## **PLANNING COMMISSION MEETING**

**Wednesday, August 19, 2026 at 6:00 PM**  
**Hamburg Township Hall Board Room**

**To:** Planning Commissioners  
**From:** David Rohr  
Planning and Zoning Director  
**Date:** August 19, 2026.

**Project address and Description:** Combined Site Plan Review (PZBA 26-0004) for a golf simulator/restaurant in an existing commercial building at 9704 Kress Road (TID 15-21-405-016). Project will include exterior renovations to commercial building and installation of new parking lot to the south. Applicant has requested waivers to the landscaping and parking requirements.

DRAWING TITLE:  
**ELEVATIONS**

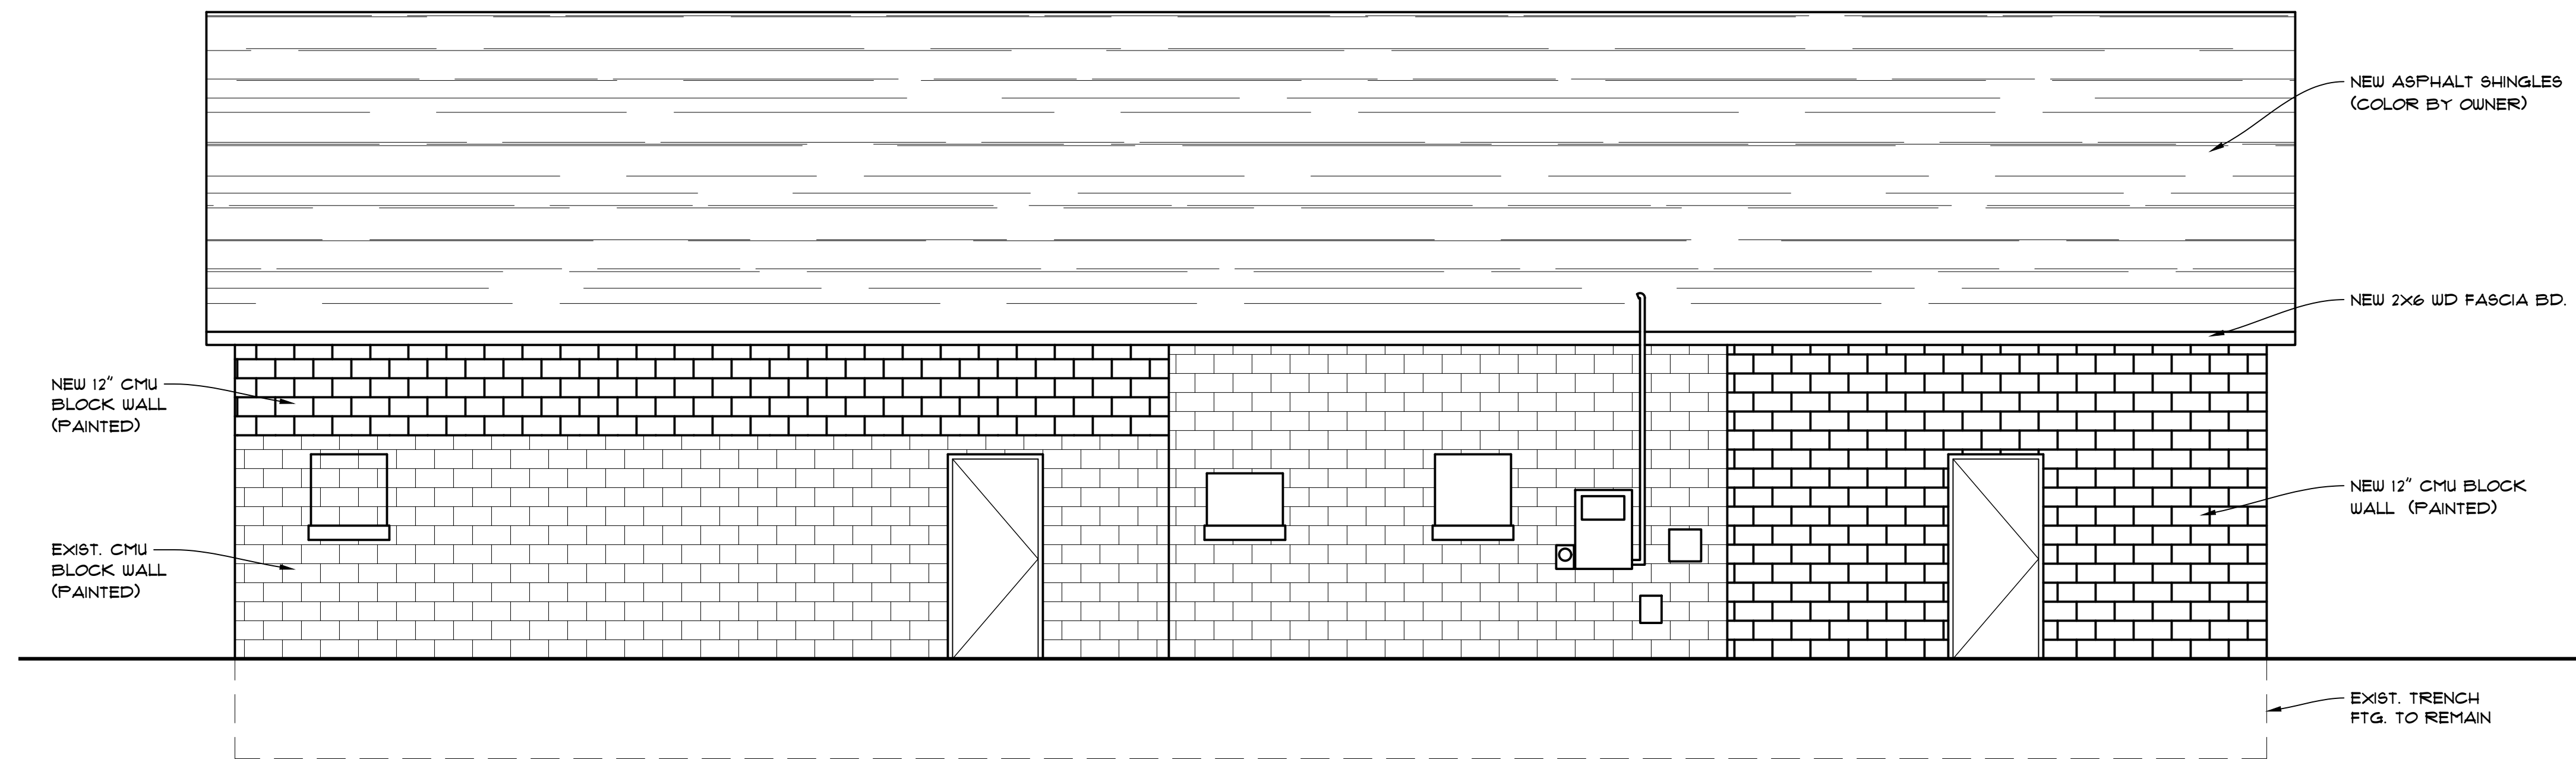
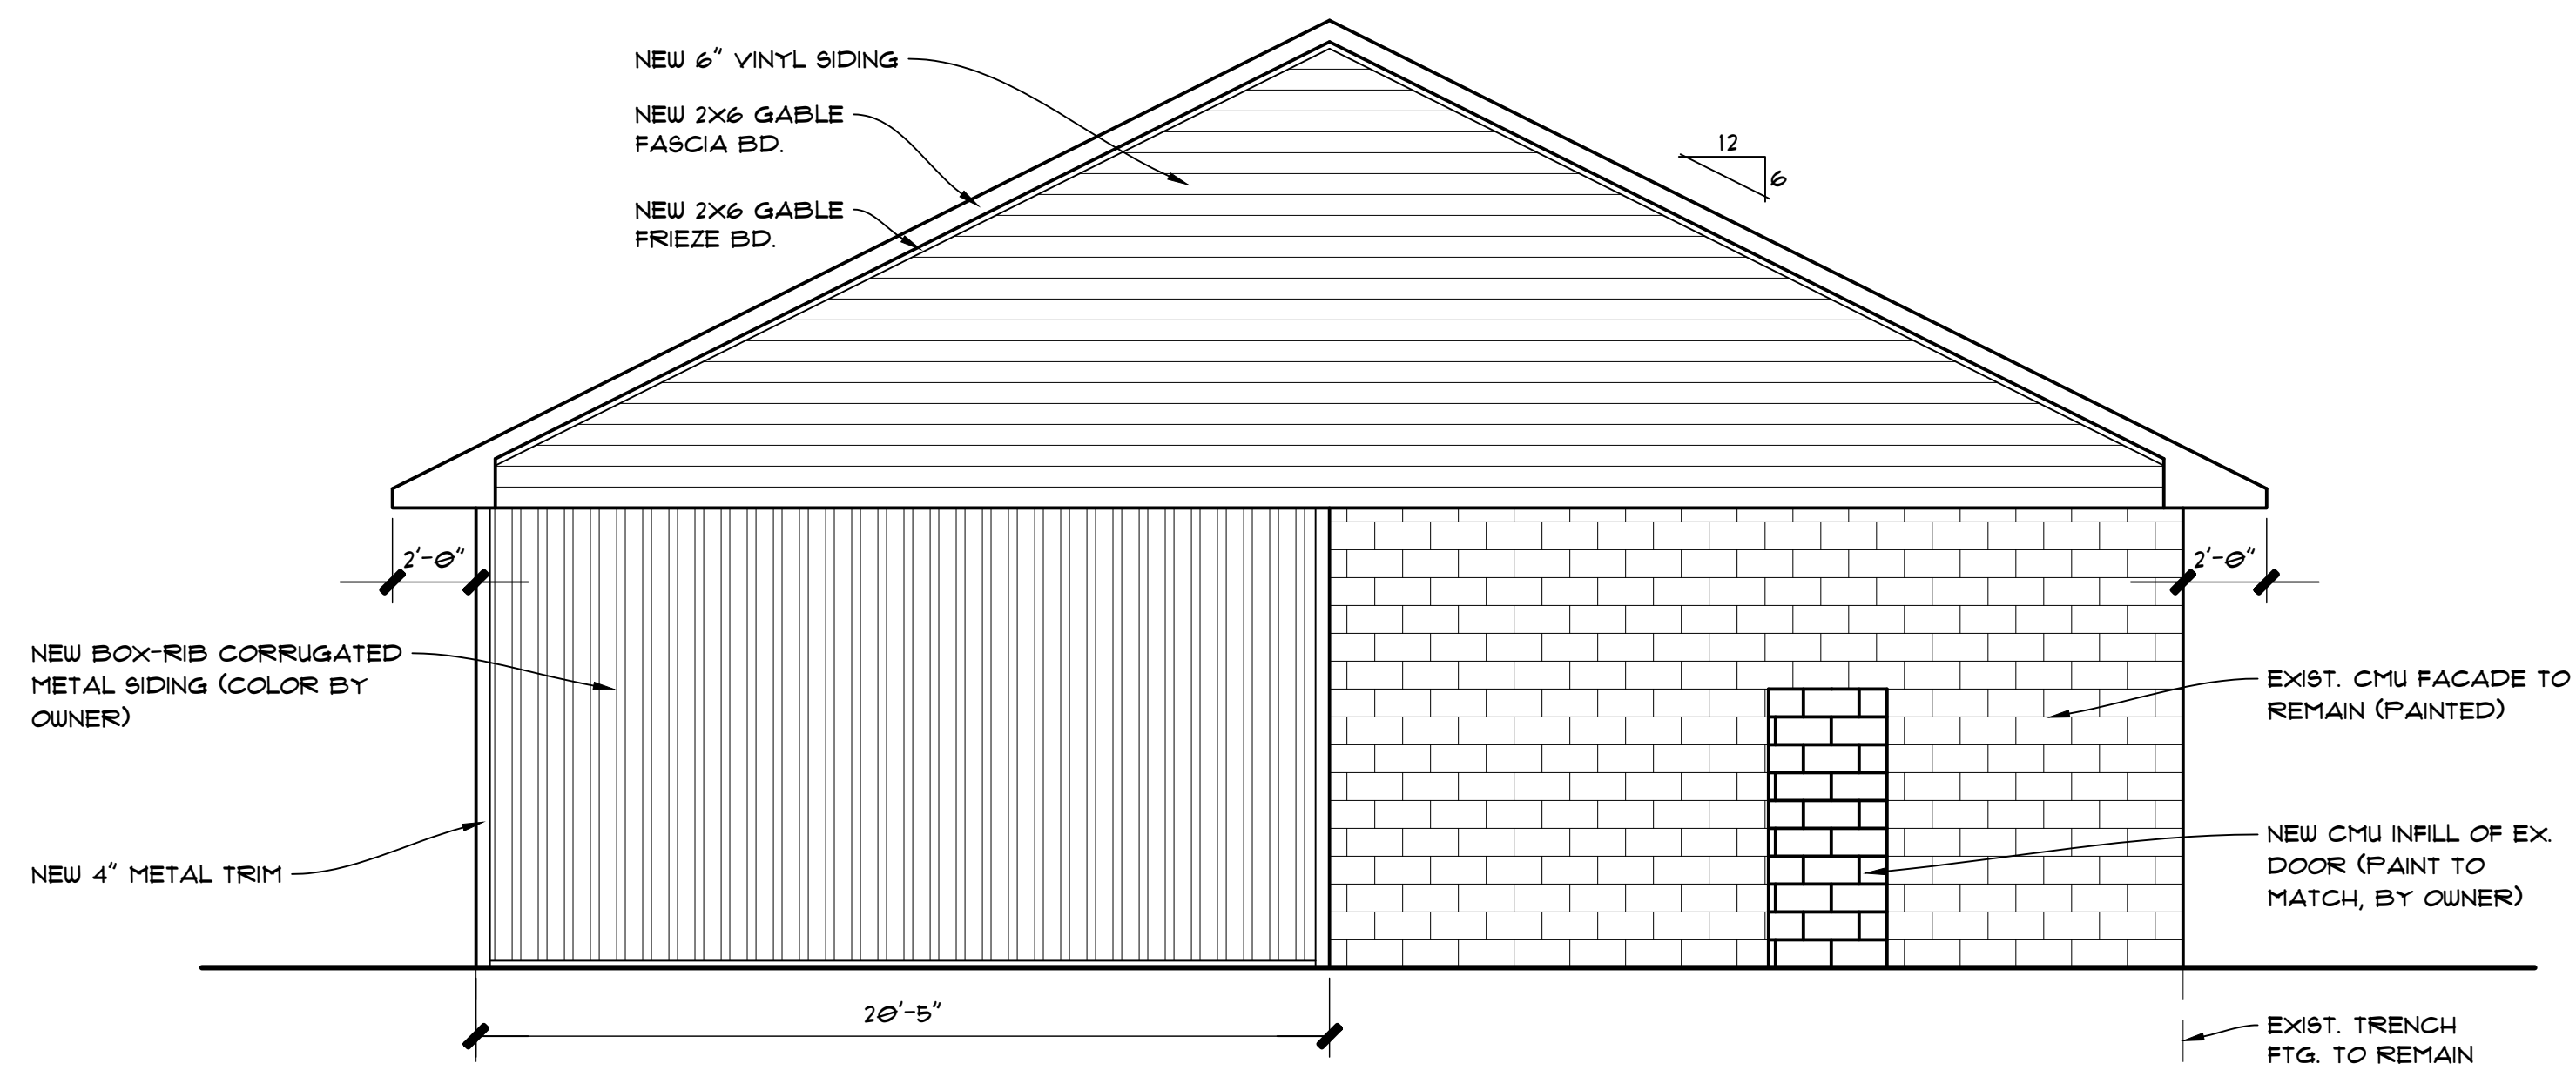
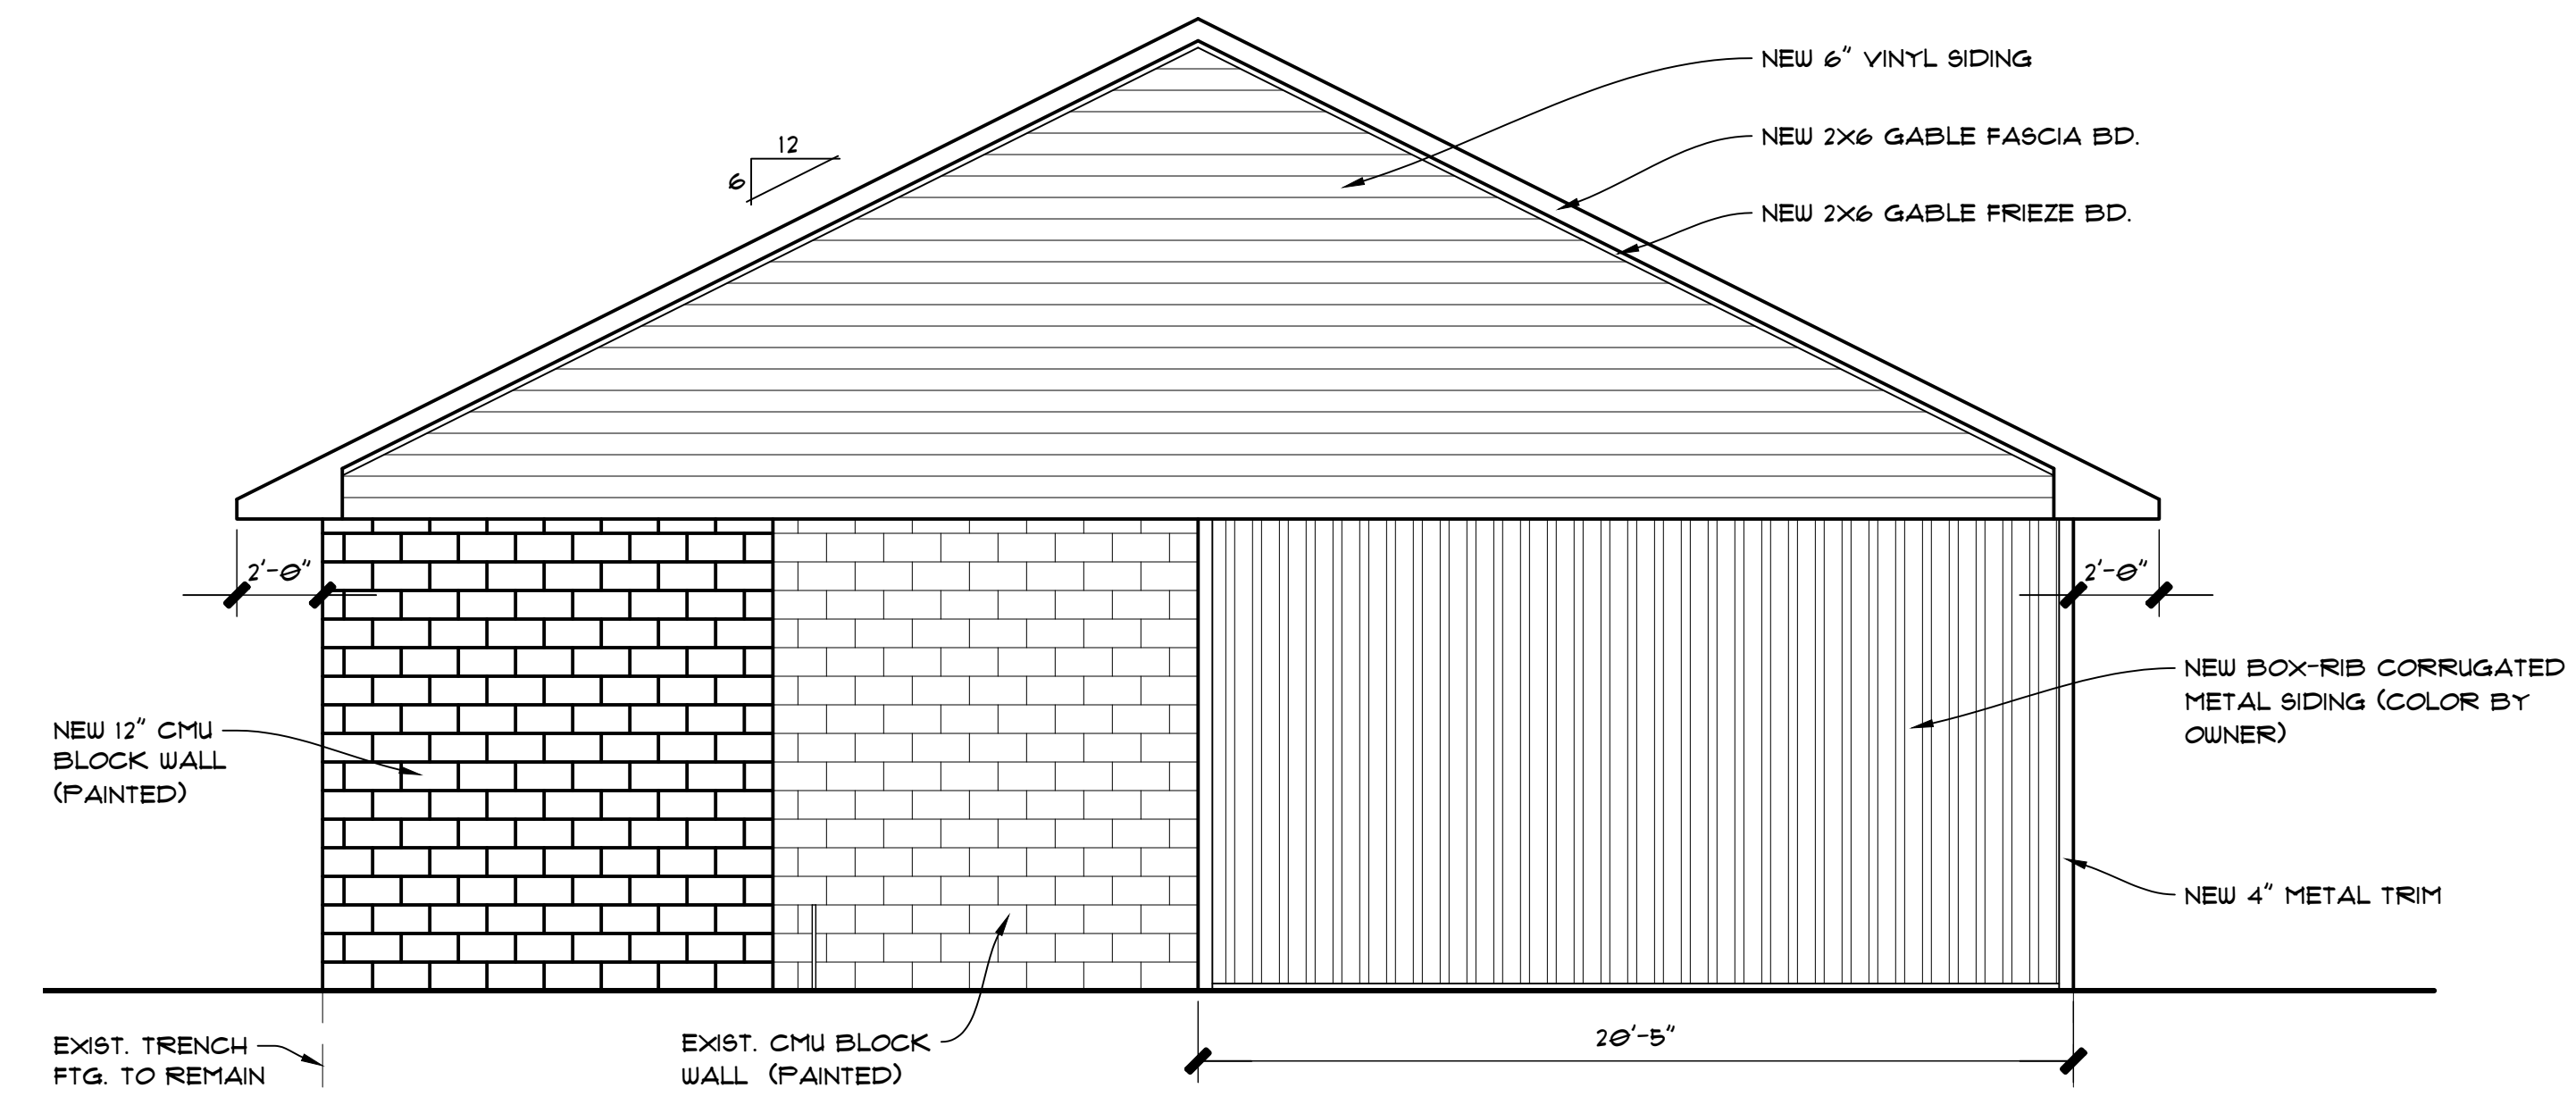
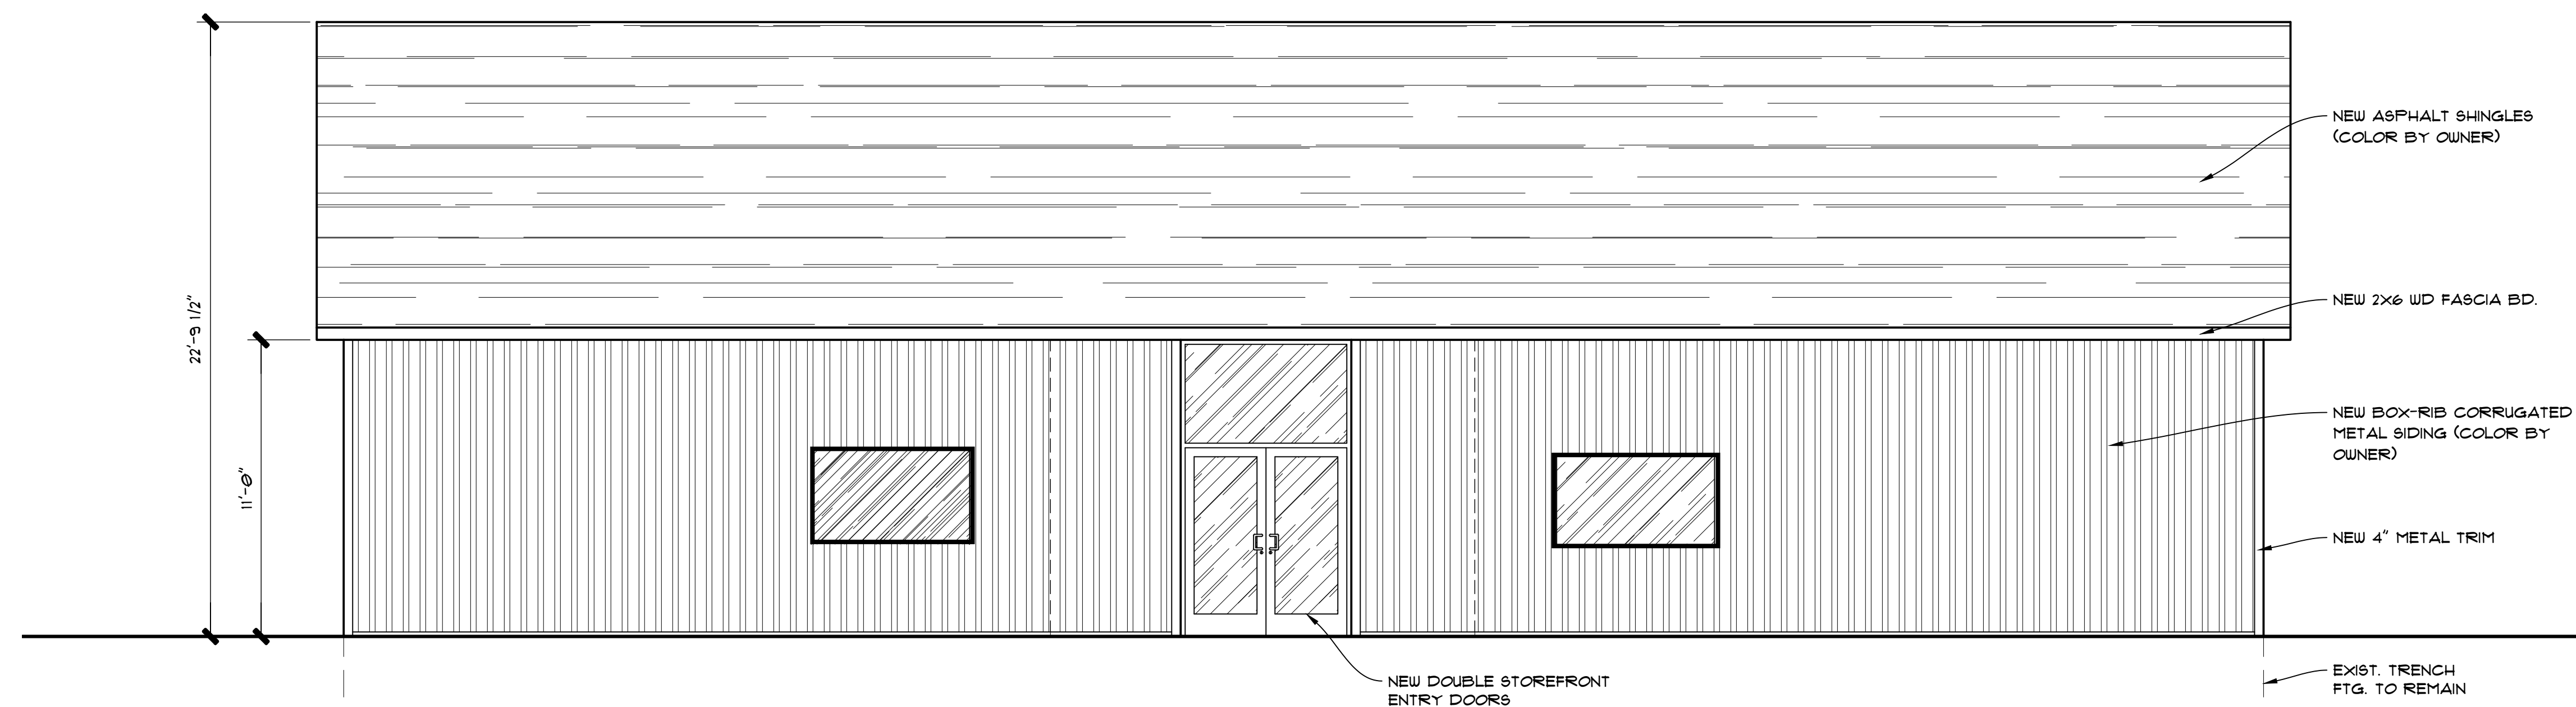
The proposed use will utilize the existing structure on the site. The changes proposed to the existing structure will provide much needed upgrades to the exterior aesthetic. The design is compatible with adjacent uses.
